SUBJECT: Submission of Annual Report

**1998  
Annual Report  
of the  
AFRRI TRIGA  
Reactor**

10 CFR 50.59 Safety Evaluations of Modifications, Changes, and Enhancements to  
Procedures or Facilities

Figure 3-6.  
WATER PURIFICATION AND COOLING SYSTEMS

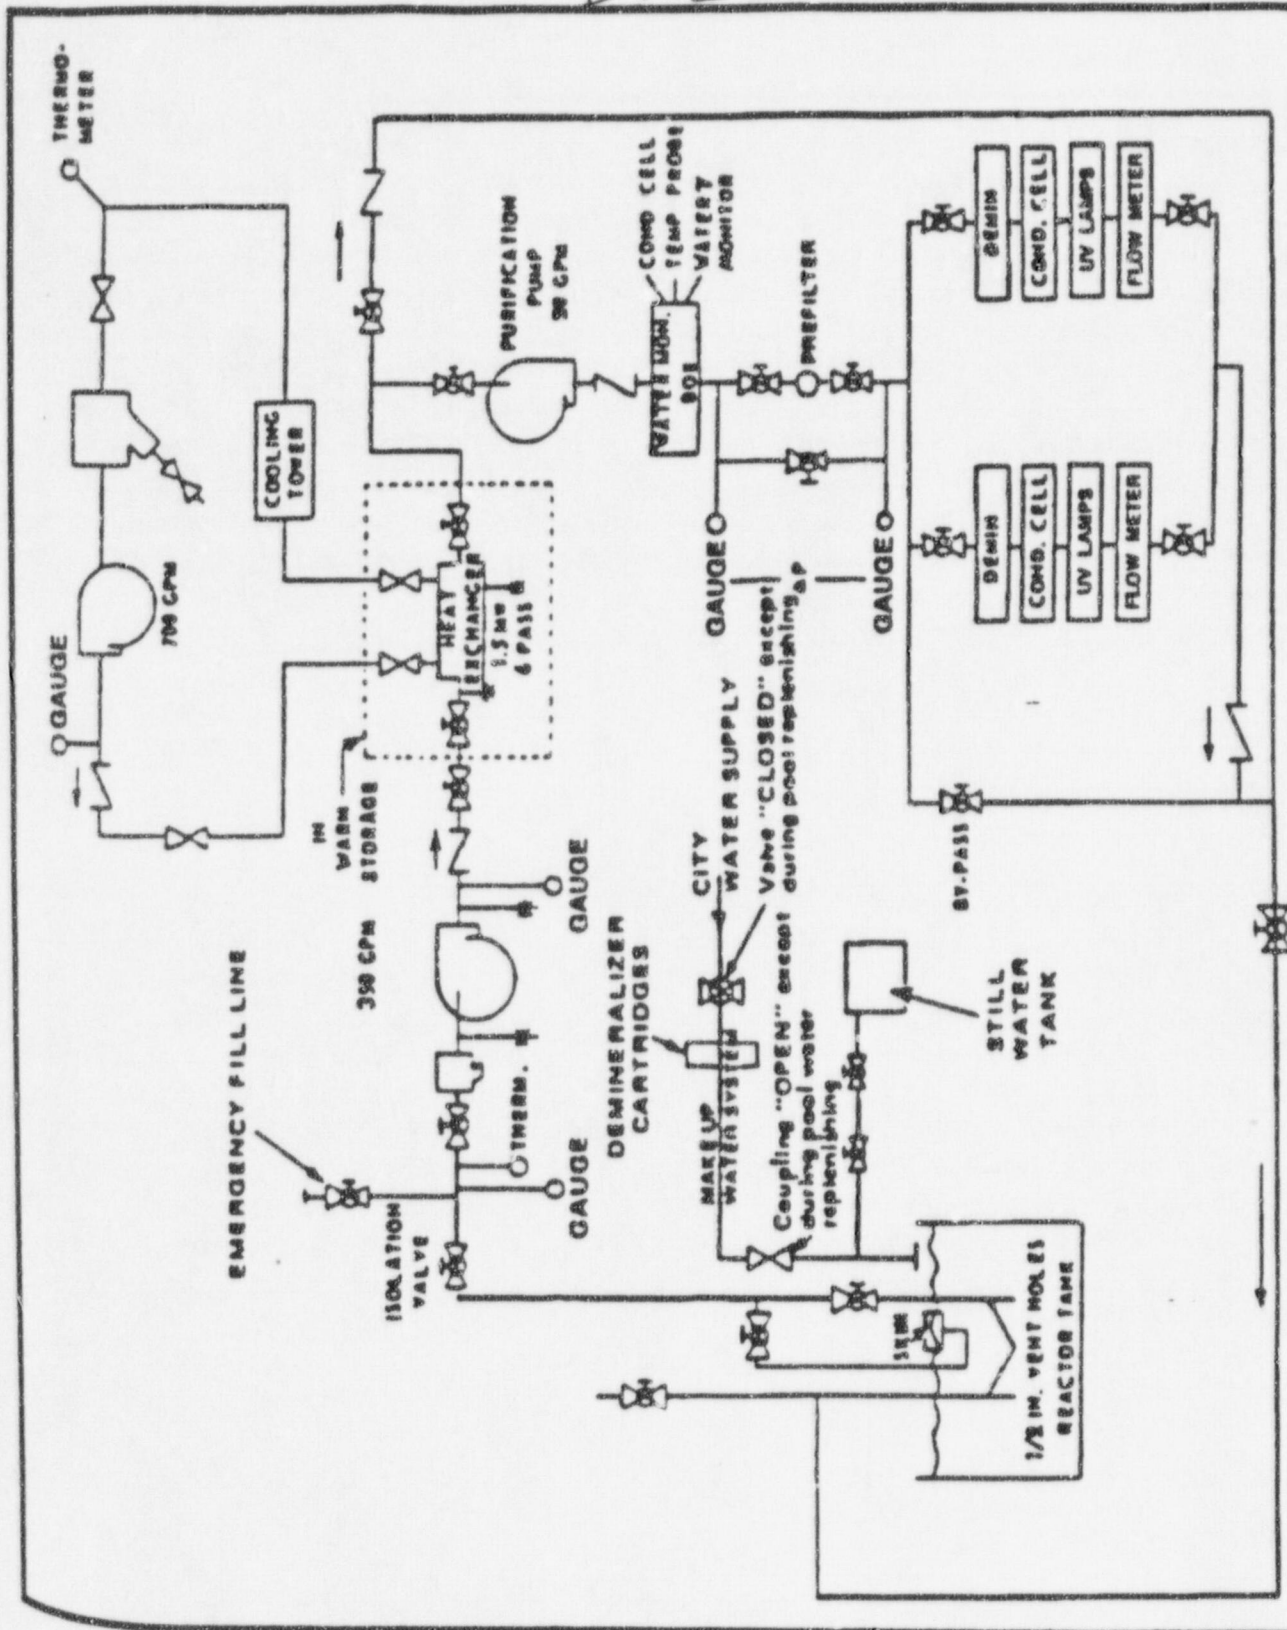
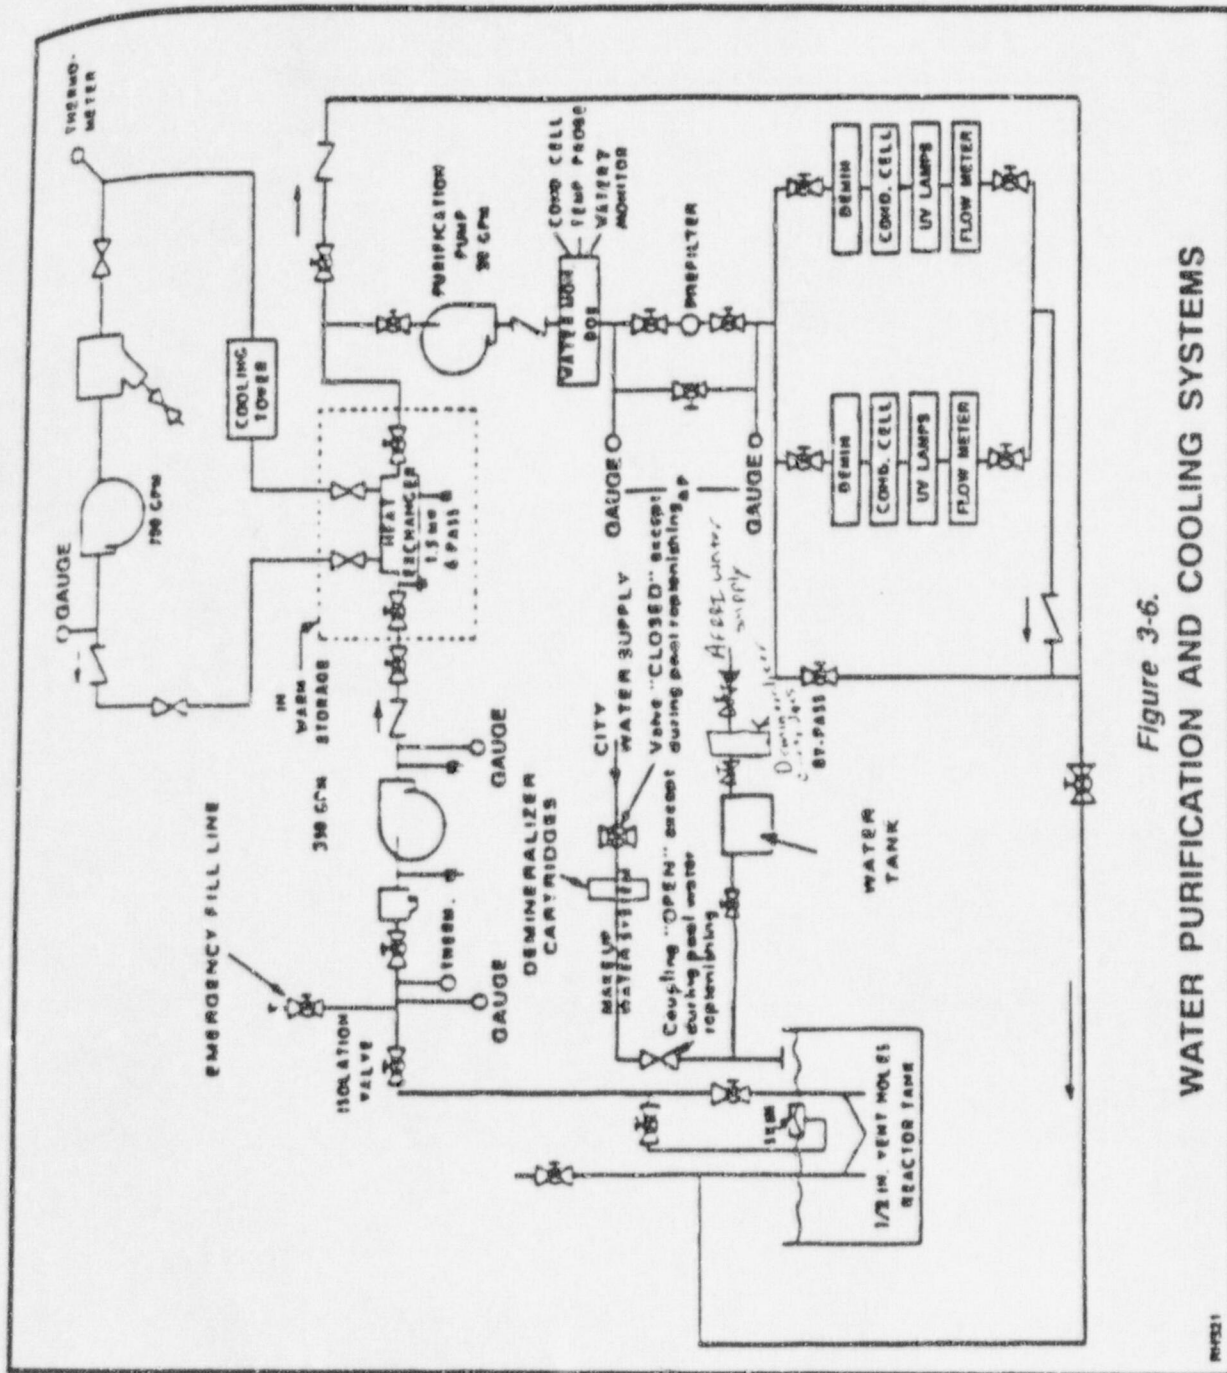
Drawing 3-6 on page 3-44, change still water tank to water tank

Figure 3-13.  
AFRI RADIATION MONITORS ASSOCIATED WITH AFRI-TRIGA REACTOR  
THIRD LEVEL

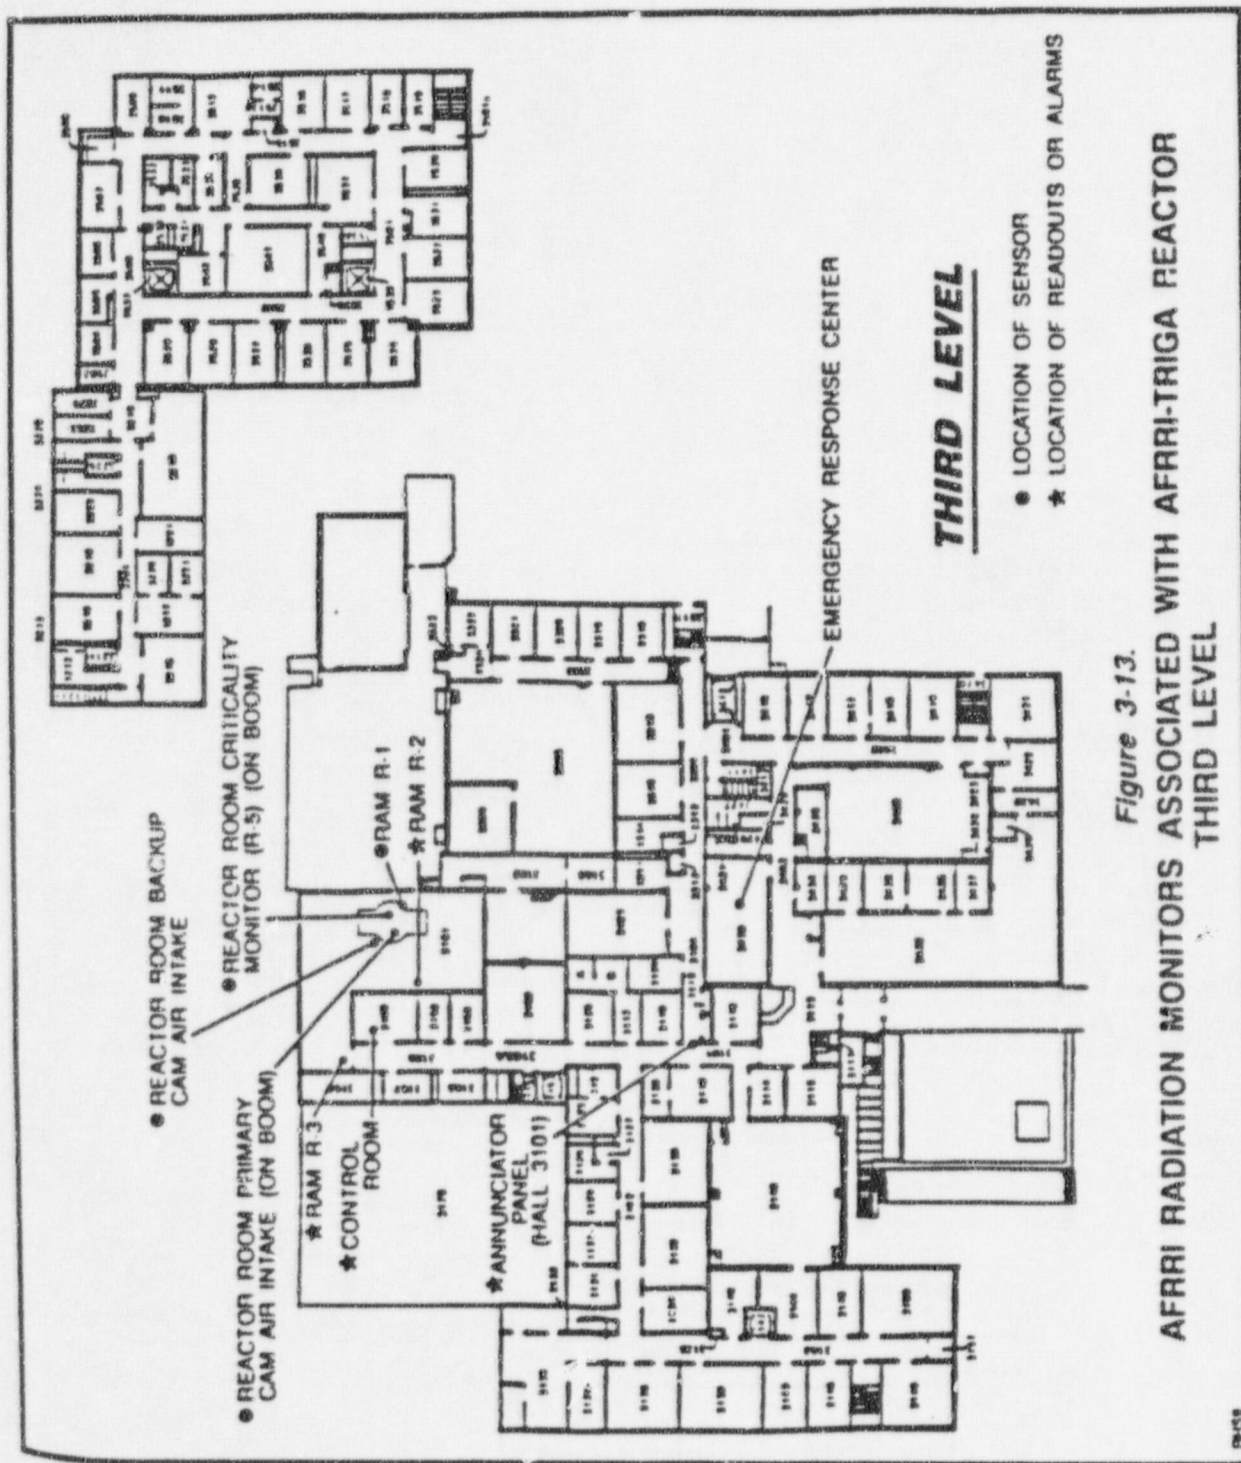
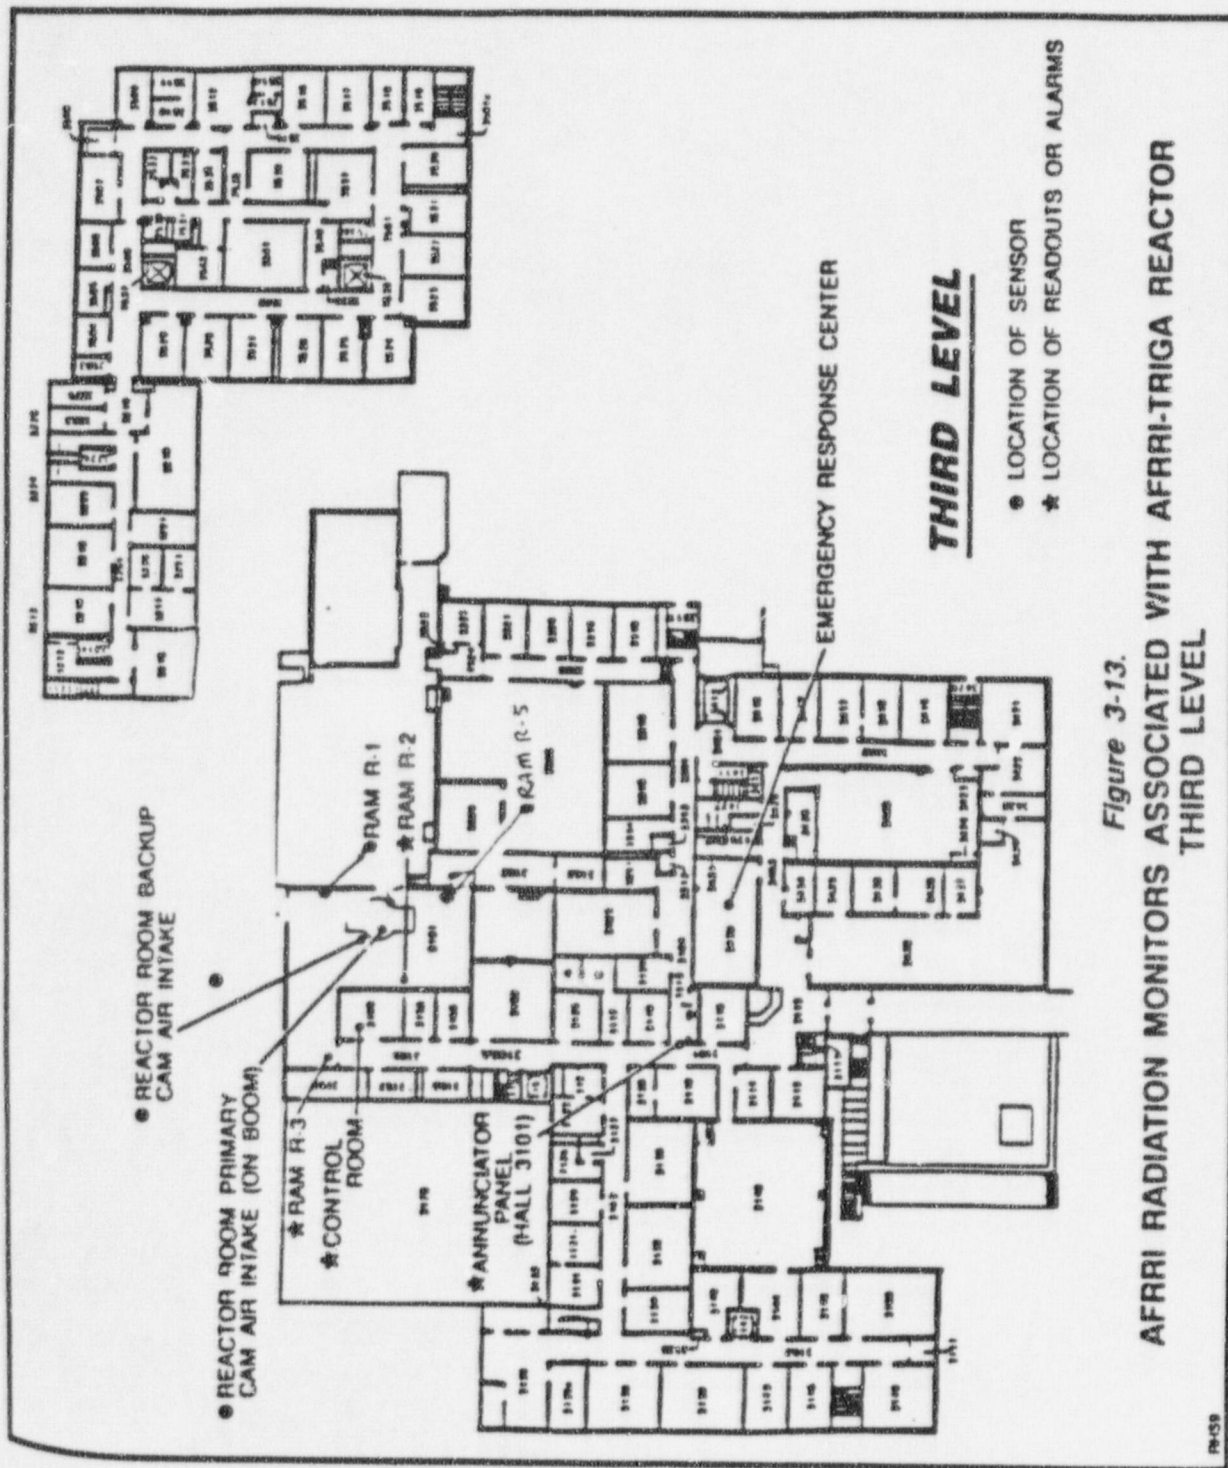
This change is to remove all references to the Radiation Area Monitor (RAM) R5 from the SAR. RAM R1 will be moved from above the reactor pool to the east wall of the reactor room over the hot table, and RAM R5 will be moved to another location in the reactor room and be used as a spare RAM. Both RAMs will have a designated alarm point set to alert personnel of radiation in the area of the detector.

Figure 3-13 RAM locations and names.

Figure 3-6.  
WATER PURIFICATION AND COOLING SYSTEMS

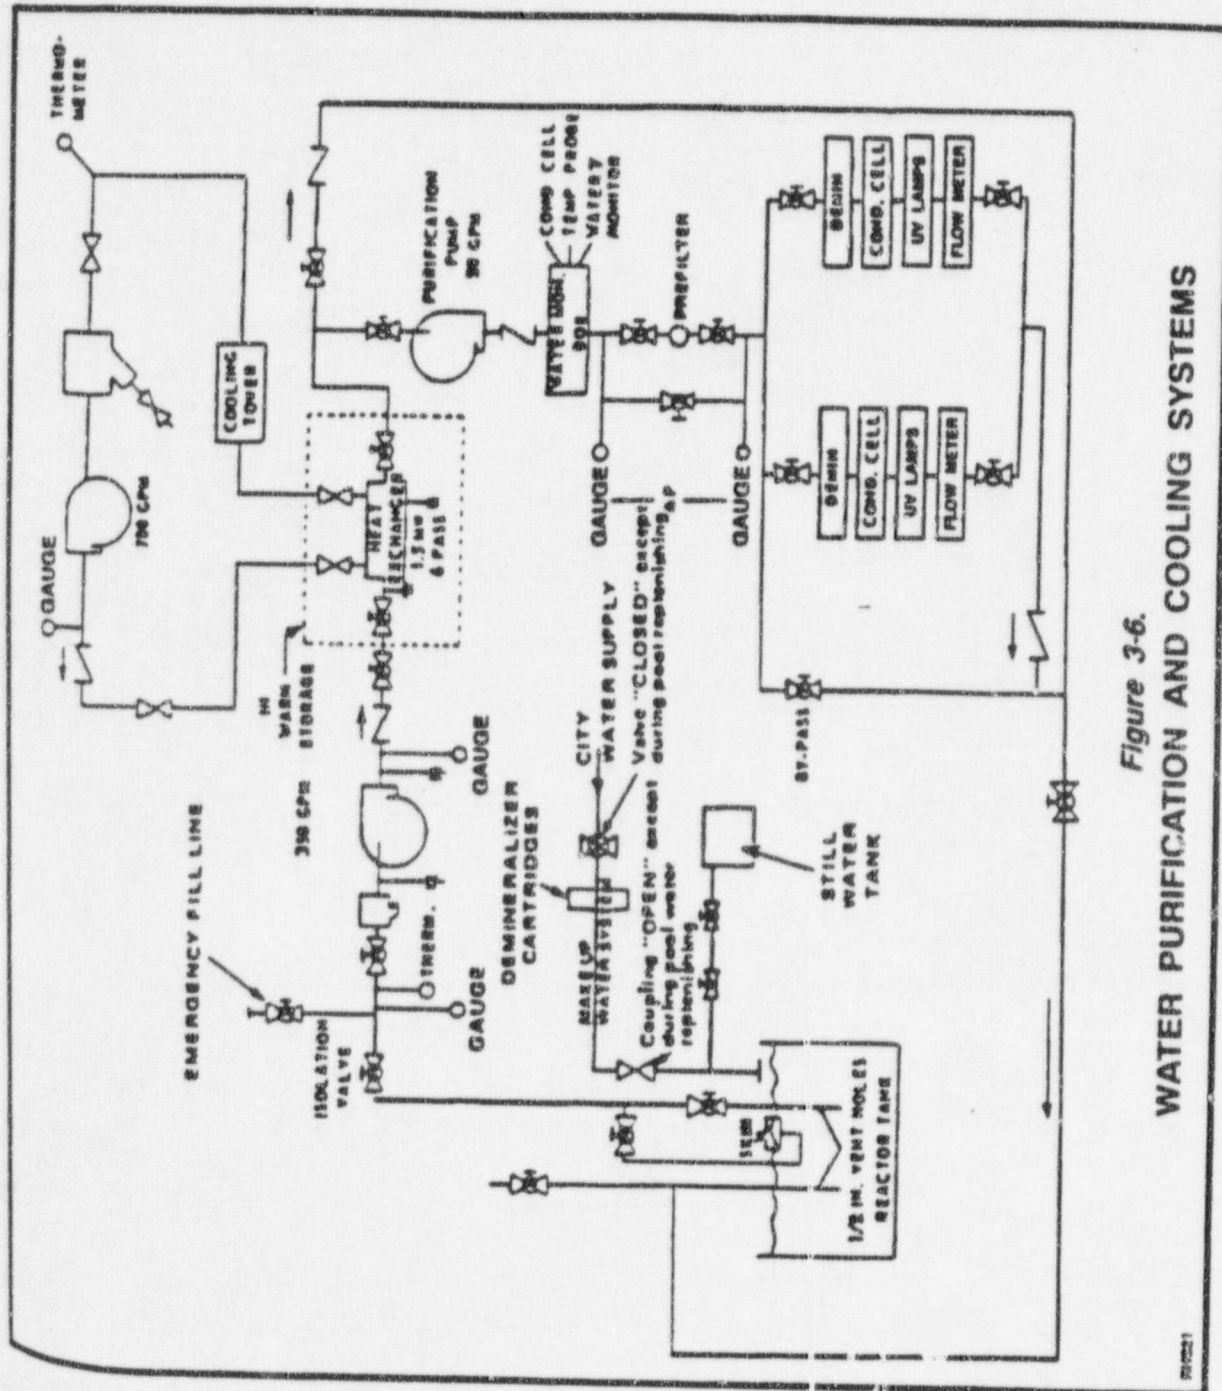
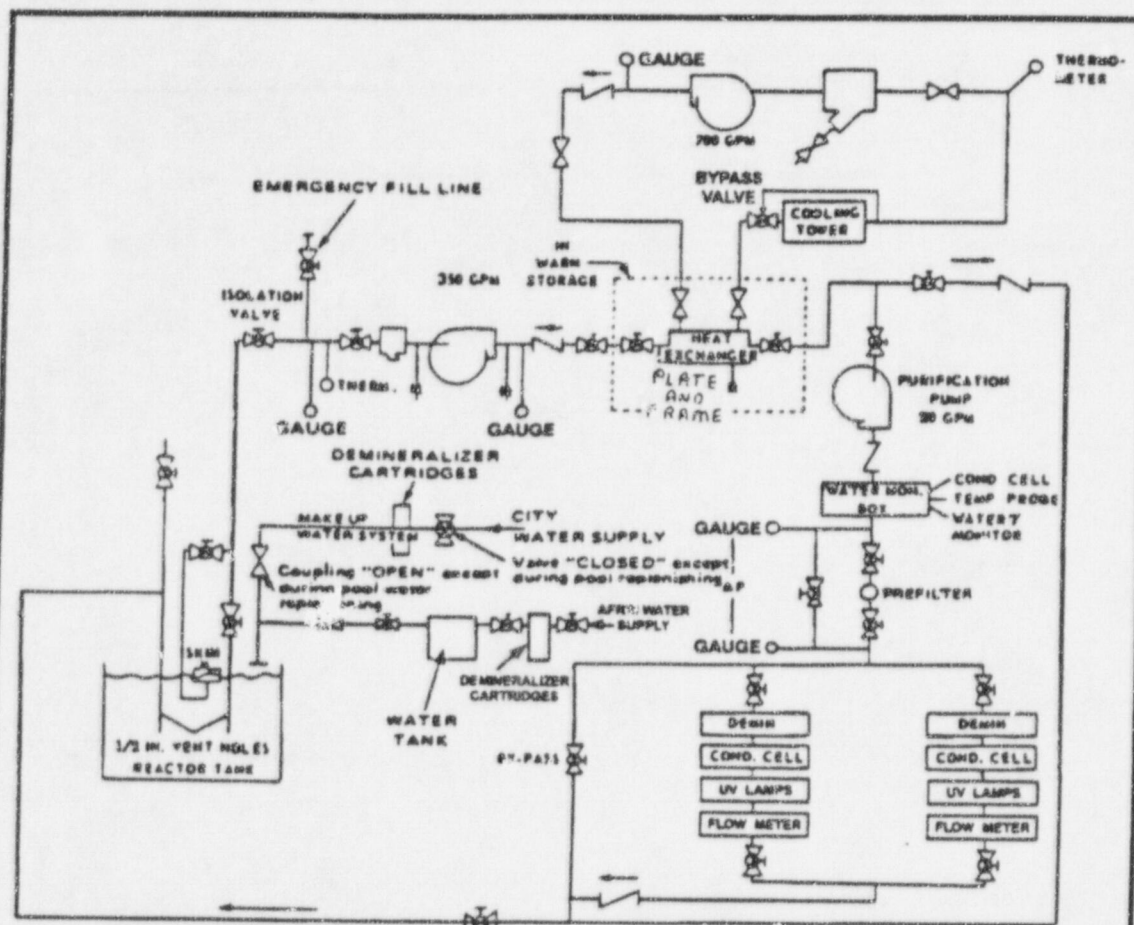
Fig 3-6 will need slight modification. the diagram of the water purification and cooling systems currently specifies that the heat exchanger is a 1.5 Mw 6 PASS heat exchanger located IN WARM STORAGE. this will have to be changed to reflect a PLATE AND FRAME heat exchanger in room 2158.
